**State Water Resources Control Board
Eagle Mountain Pumped Storage Project
(FERC Project No.13123)**

**Responses to Comments on July 2010
Draft Environmental Impact Report (SCH #2009011010)**

**RE: COMMENTS ON THE DRAFT EIR FOR THE EAGLE CREST ENERGY
COMPANY EAGLE MOUNTAIN PUMPED STORAGE PROJECT (STATE
CLEARING HOUSE No: 2009011010)**

Figure Kaiser-2: Comparison of Estimated Annual Recharge to Chuckwalla Aquifer as Developed by Various Authors.
 (A recharge estimate of 12,000 AFY was used in the Draft EIR.)

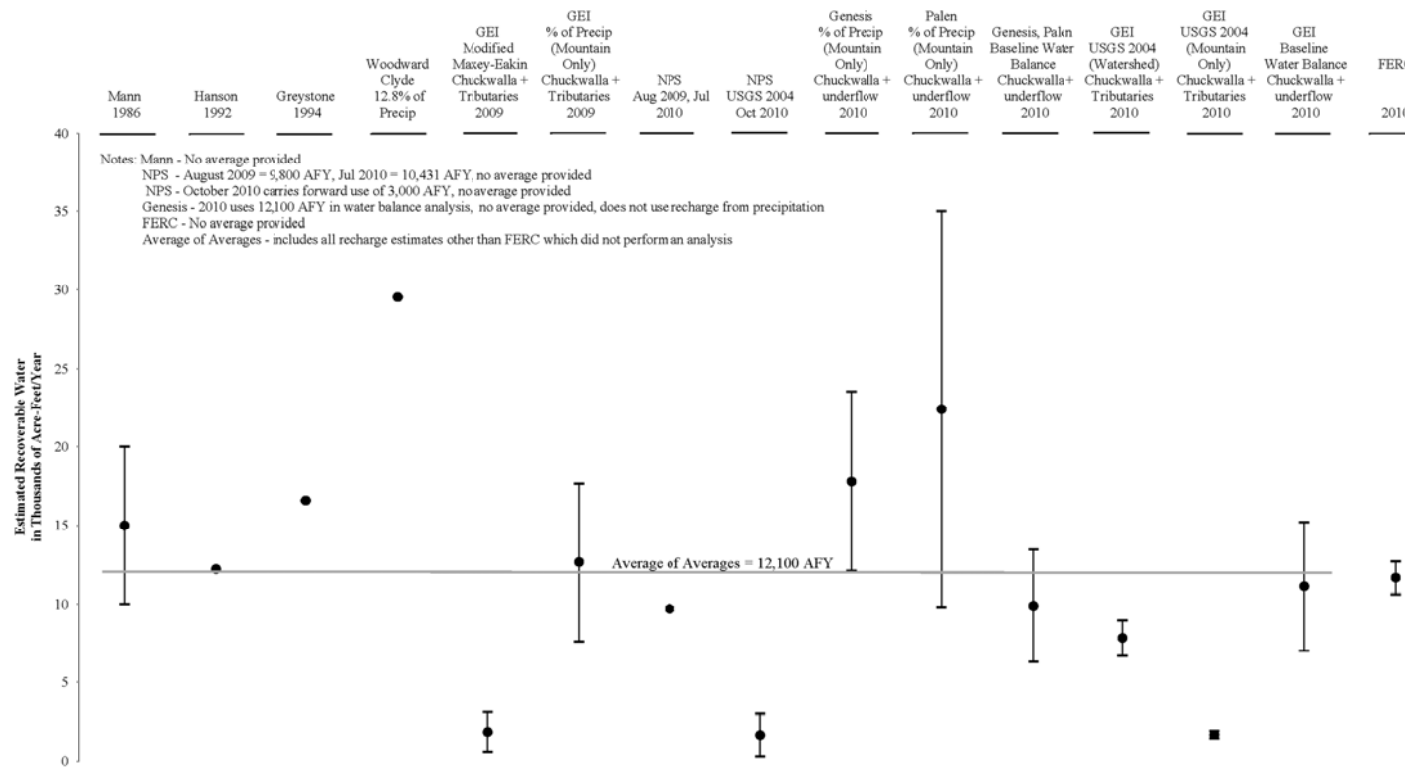
Response to Kaiser #17-4.1: Three recent EISs have been released which review the potential impact of proposed solar energy projects on the Chuckwalla Valley (Palen Solar Energy Project EIS; Genesis Solar Energy Project EIS; and Desert Sunlight Solar Energy Project EIS). These documents include an analysis of potential impacts of solar project water use on the Chuckwalla aquifer. In addition, comments provided by the National Park Service (NPS) included an alternative estimate of recharge to the Chuckwalla aquifer. This response summarizes these other groundwater analyses and makes a comparison to the groundwater analysis provided in the Draft EIR.

Recharge to the Chuckwalla aquifer was calculated to be 12,700 acre-feet per year (AFY) for use in calculations of the water balance in the Draft EIR. This recharge estimate is near the mean estimate of recharge for the aquifer as developed by numerous authors. Figure Kaiser-2 shows a summary of groundwater recharge estimates for the Chuckwalla and tributary valleys using: the estimates developed during previous studies; the baseline water balance estimates developed for Response to NPS #14-5; estimates based on an approach outlined by the United States Geological Survey (2004); NPS estimates from July and August 2010; recent recharge estimates used by state and federal agencies for the proposed solar projects in the valley; and previous estimates developed by the Project Applicant.

As Figure Kaiser-2 illustrates, estimates of recharge for the Chuckwalla aquifer range from a low of 3,000 AFY as suggested by the NPS in its October 2010 comment letter on the Draft EIR submitted to the State Water Board (a copy is included in this Responses to Comments), to a high over 30,000 AFY in the Palen Solar Power Project EIS. The recharge estimates at the very low range of values would predict drawdown in the valley much greater than has been actually observed in groundwater levels. Therefore, these very low estimates of recharge are deemed inaccurate and unreasonable for use in water balance modeling. As shown in Figure Kaiser-2, the average of these estimates is 12,100 AFY, and the average with high and low outliers eliminated is 12,500 AFY, supporting the conclusion that the 12,700 AFY recharge estimate used in the Draft EIR is both conservative and reasonable.

FIGURE 2
ACCUMULATION OF TOTAL DISSOLVED SOLIDS AND ARSENIC
EAGLE MOUNTAIN PUMPED STORAGE PROJECT

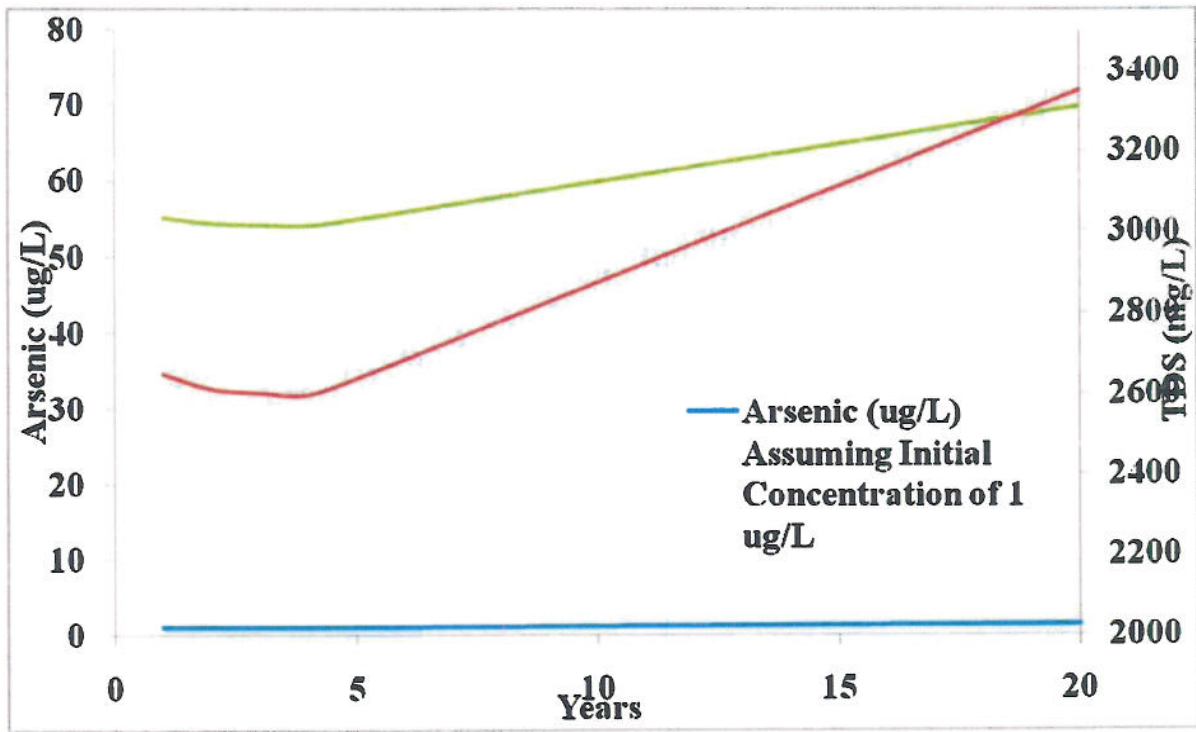
No specific groundwater characterization data are provided in the TM, with the exception that the groundwater supply is expected to contain 2,400 ppm of TDS. Calculations indicate that, despite the RO system's removal of TDS, the TDS concentration in the reservoir will increase over time (Figure 2). Similarly, if hazardous constituents (e.g., arsenic, selenium, mercury, etc.) should be present in the water then their concentrations will also increase over time.

Arsenic is a hazardous constituent that is often a concern in California groundwater supplies. The Project appears to be in a region of California that typically contains between 1 and 50 micrograms per liter ($\mu\text{g/L}$) of arsenic (Figure 3). For reference, the Maximum Contaminant Level (MCL) for arsenic in drinking water is 10 $\mu\text{g/L}$. As

shown in Figure 2, the concentrations will increase over time and may exceed the MCL already, depending on the pumped groundwater quality.
